Addendum No. 3
February 18, 2021

Project: Fine Arts Colton Theatre Renovation
University of South Dakota
Vermillion, South Dakota
OSE Project #0621--09X
Architecture Incorporated Project #2906

Architect: Architecture Incorporated

4) DRAWING SHEET 9.70 – ELECTRICAL SCHEDULES & DETAILS

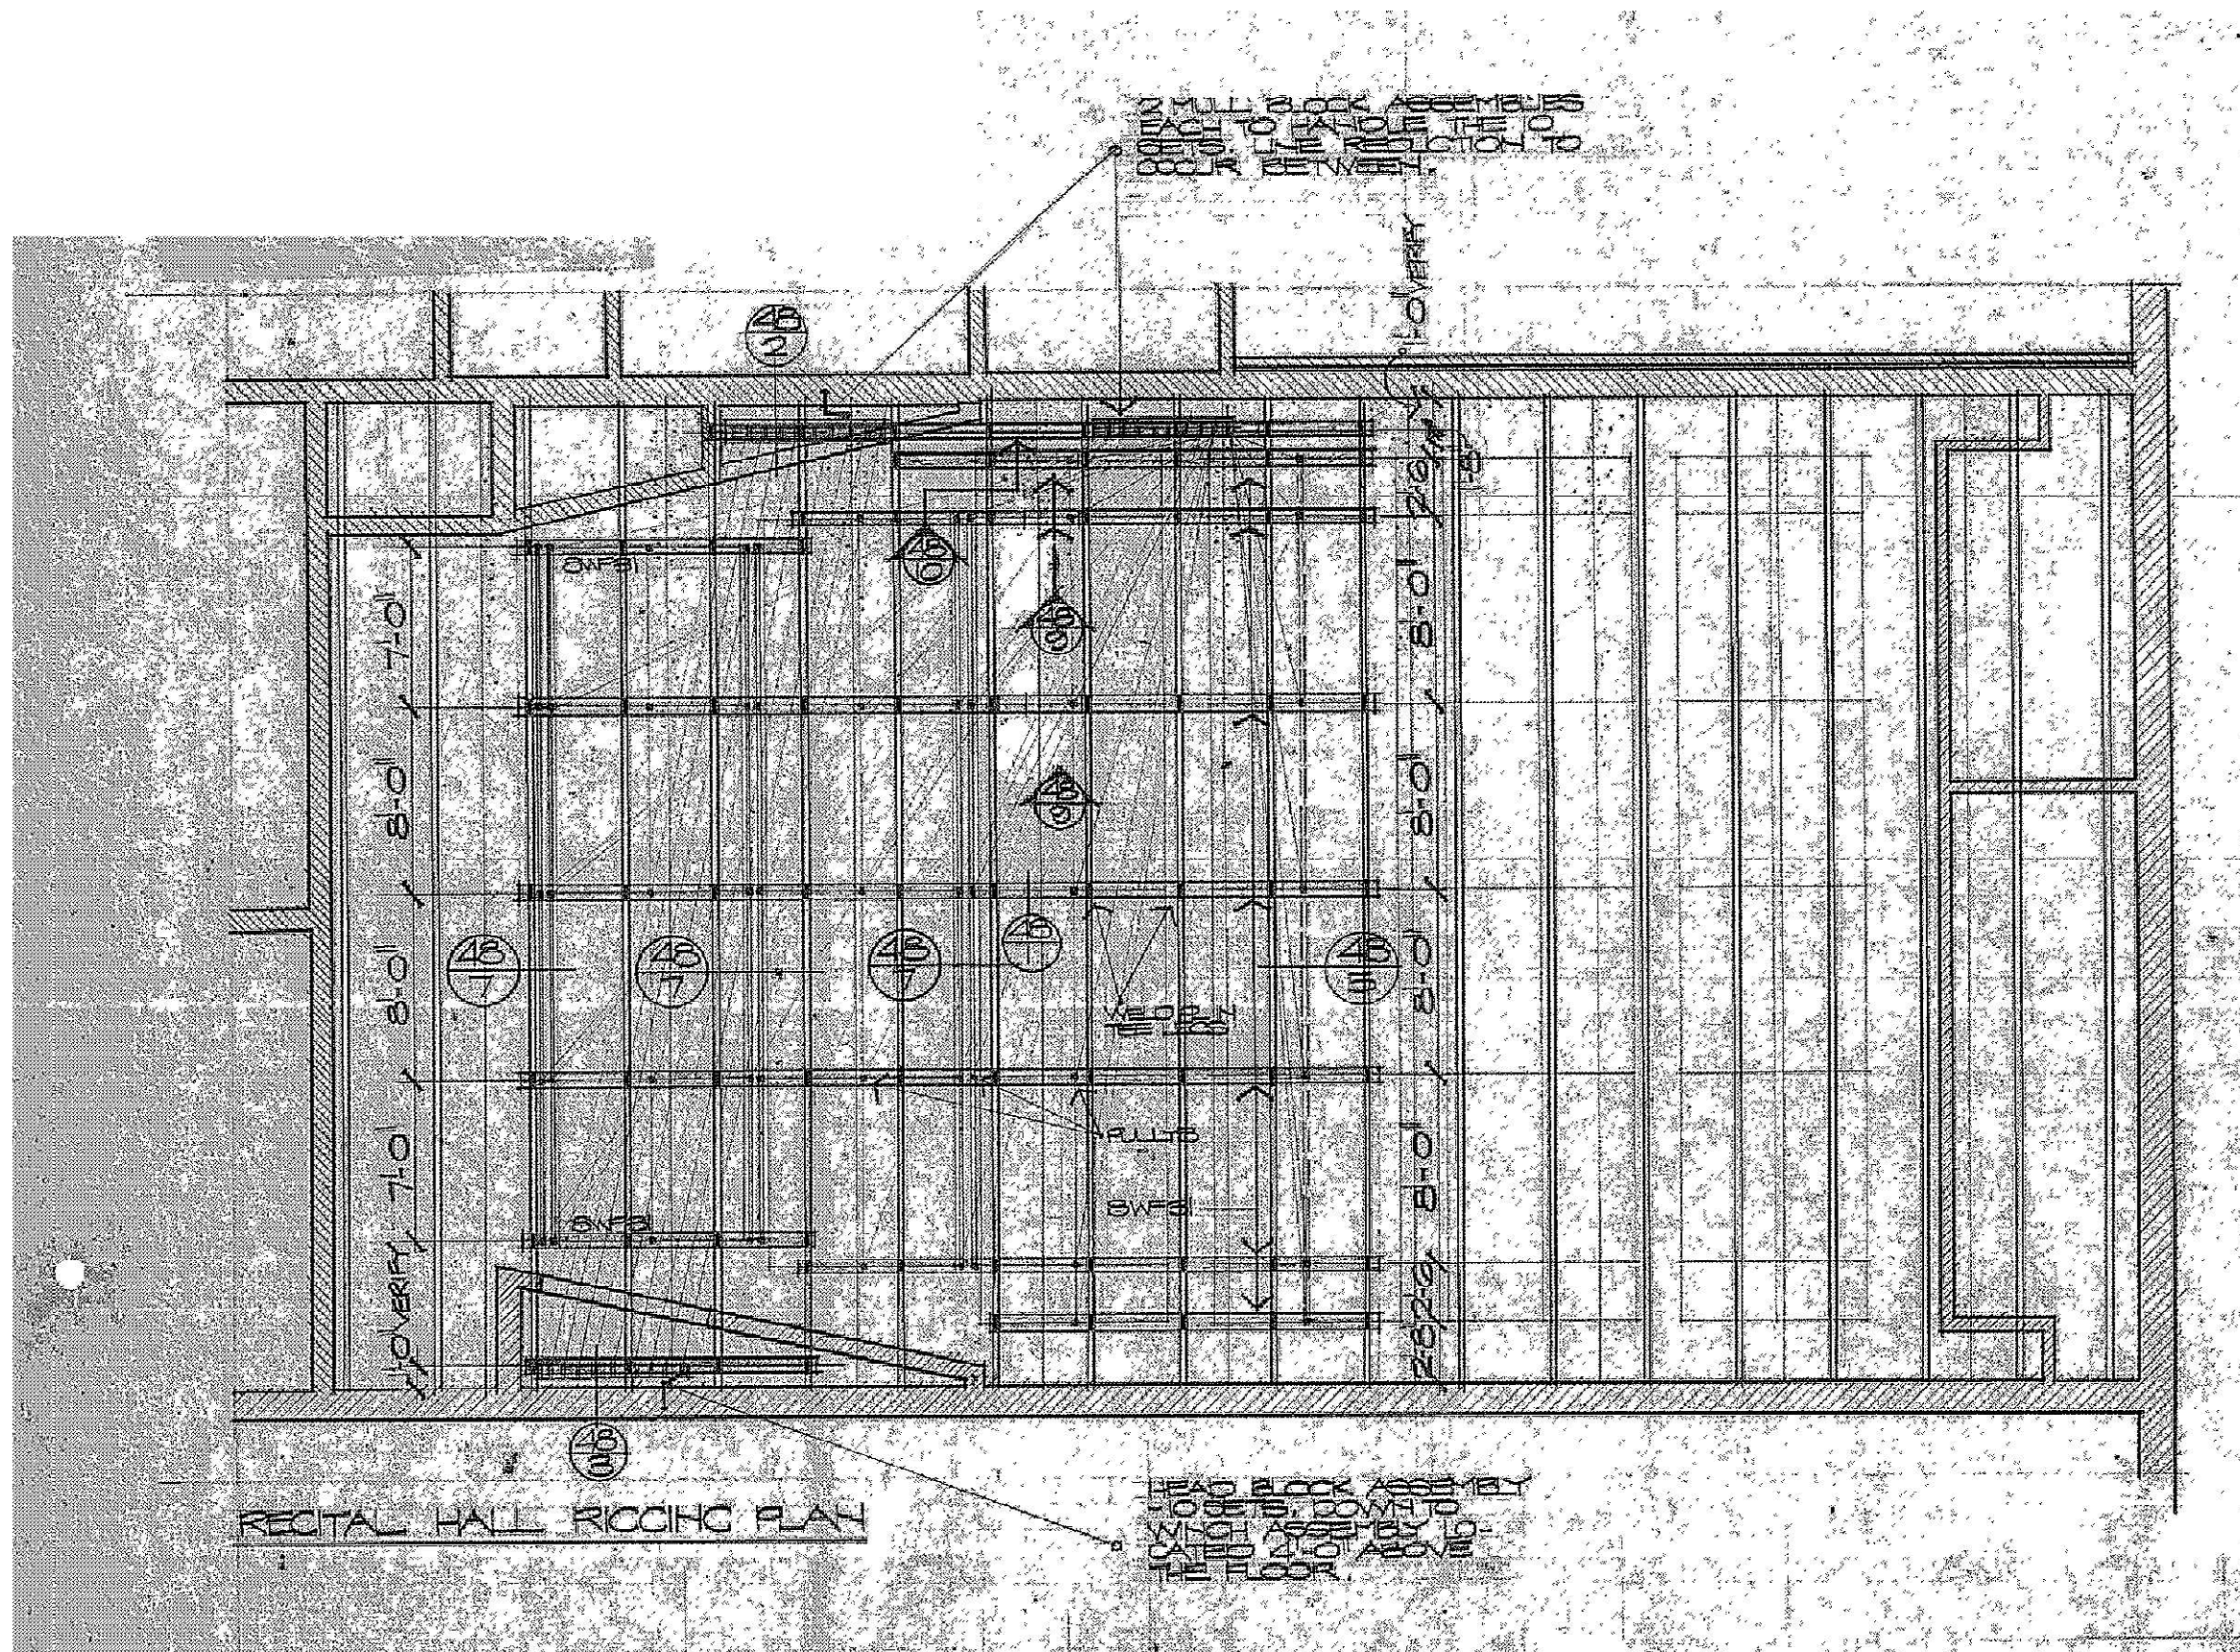
- a) Luminaire Schedule, luminaire type ‘J’: Revise description to read, “LED Trapezoidal Wall Sconce – 1200 lumens, forward distribution (alternate bid).” Revise manufacturer to Lithonia. Revise catalog number to read, “WDGE1 LED P1 30K 80CRI VF MVOLT SRM DBLXD.” Revise finish, mounting, and wattage accordingly.
- b) Luminaire Schedule, remark 10: Revise location for ETC F-Drive W1 Chroma drivers from control room 202 to control booth 204.

DRAWING TITLE:
SYSTEM RISER

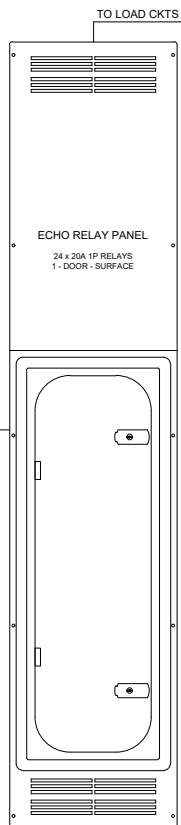
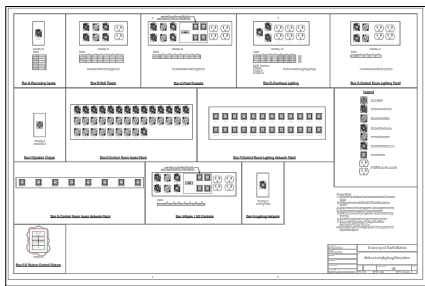
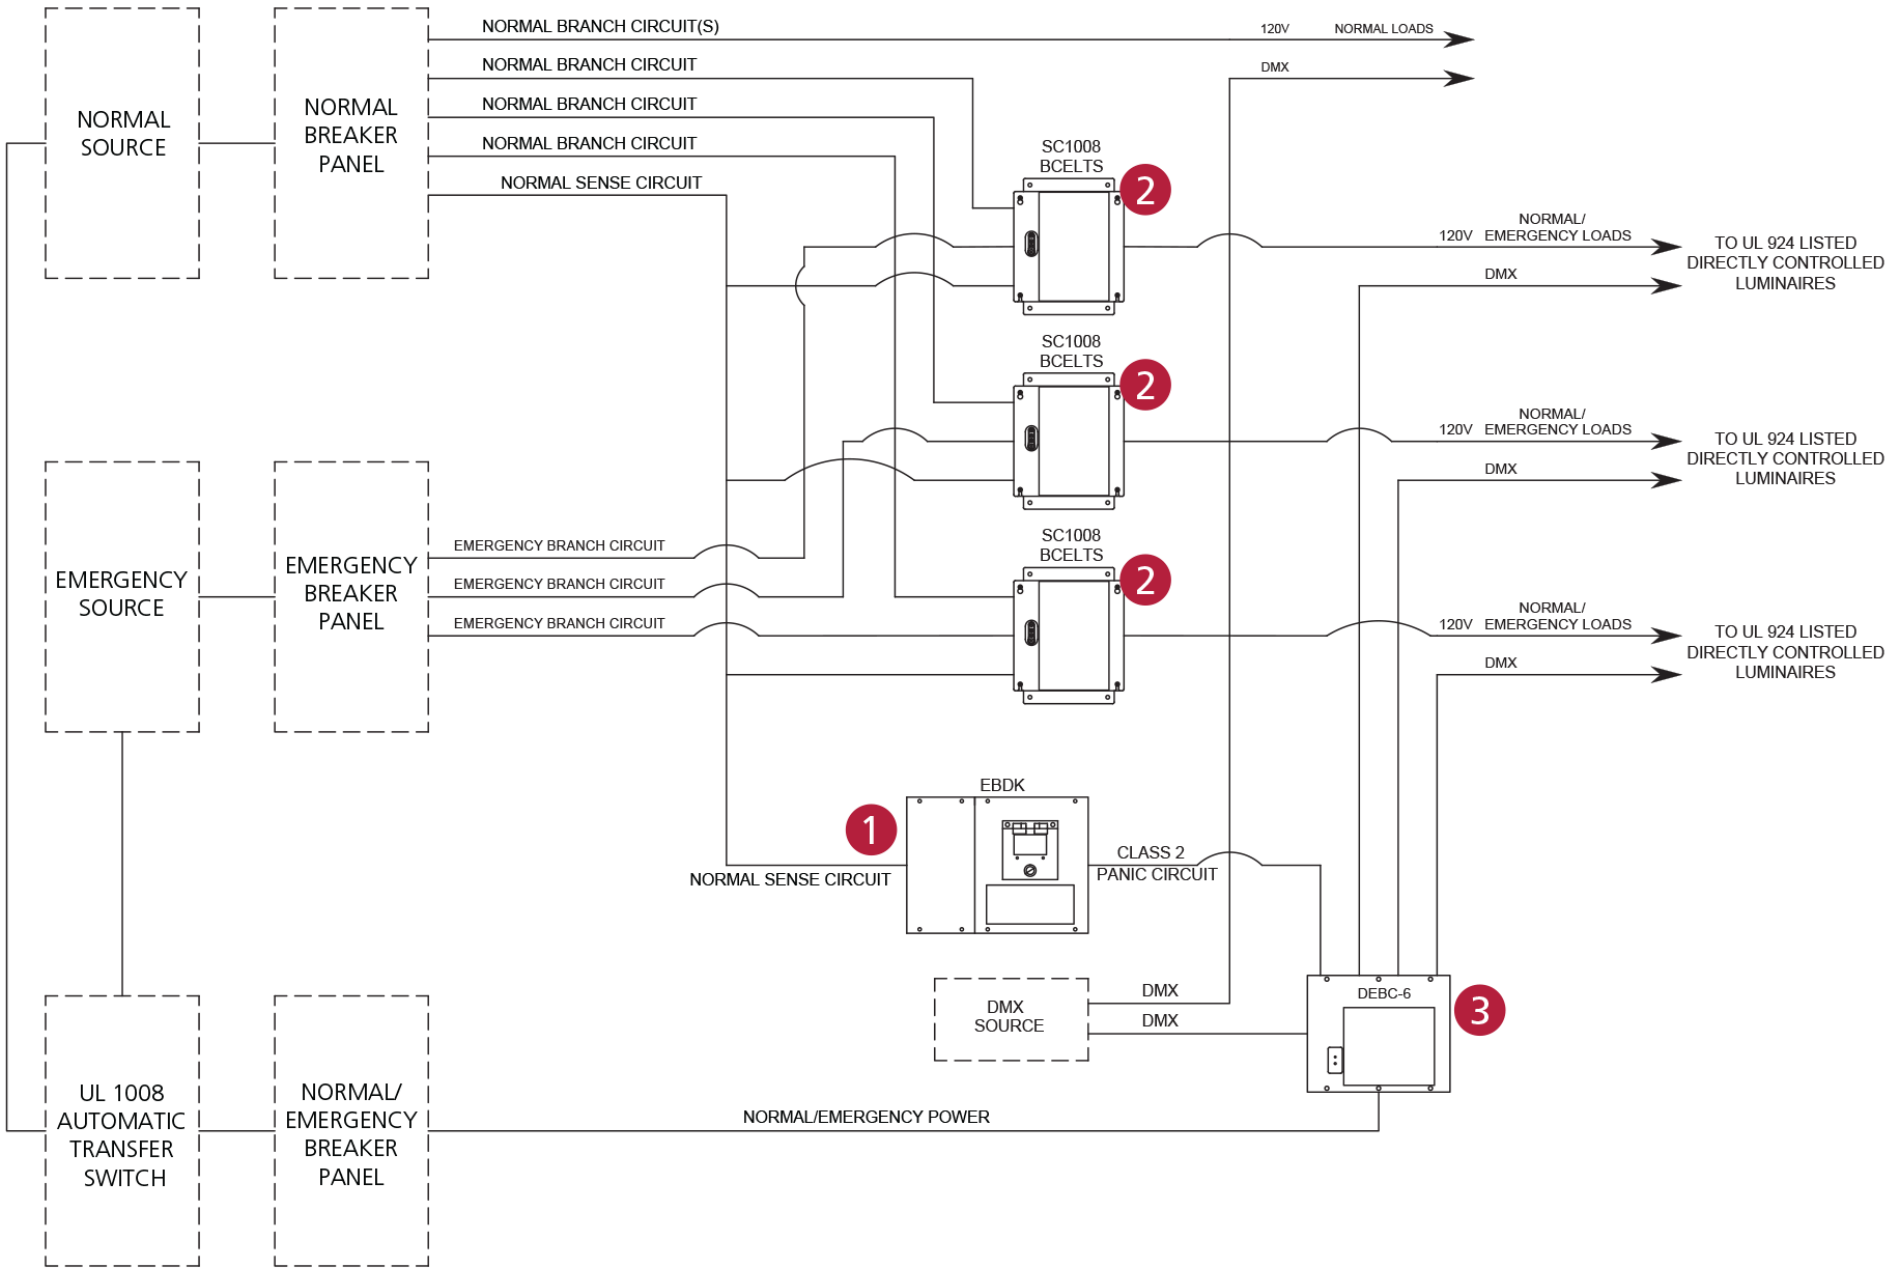
- 5) SPECIFICATION SECTION 260933 – THEATRICAL DIMMING CONTROLS & DISTRIBUTION
 - a) Preliminary Riser Diagrams, ETC Drawing 000 (2 pages), are attached to the end of this addendum for reference.
